On behalf of New York Cycle Club's three thousand members, we call on the Central Park Conservancy, as well as the NYC Departments of Transportation and Parks & Recreation, to forgo aspects of the CP Drive redesign that would jeopardize cyclists' safety.

First, we call on you to forgo installation of "tabletop crossings" as depicted in item #2 of p. 54 of the [Central Park Drive Safety and Circulation Study](#).

P. 54, Item #2, CP Drive Safety and Circulation Study, NYCDOT, 10/24

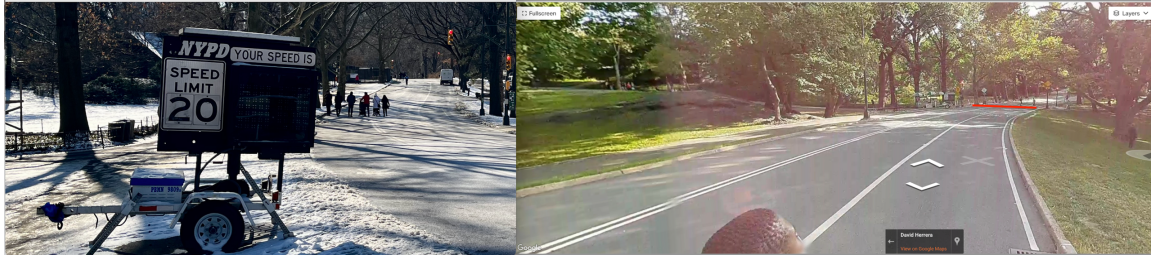
Note that the portion of the Drive spanning the Winterdale Arch and the crossing by the Delacorte, mentioned as a candidate for such treatment, comprises a 20 foot drop over the 0.1 mile—enough to propel even casual cyclists to speeds over 20 mph.

“Avoid placement of a speed hump in an area where high bicyclist speed is expected. ... A bicyclist approaching a 3-inch hump at 20 mph may lose control.” Effects of Traffic Calming Measures on Non-Motorized Users, USDOT FHWA, 7/17/24, <https://tinyurl.com/5c2nfz5a>

Plainly then, placing a 3-6” high tabletop crossing by the Delacorte would be like installing a curb at the bottom of a hill. It would not only cause cyclists of all types to crash, but also [handcyclists](#), [wheelchair racers](#) and users of [personal assistive mobility devices](#).
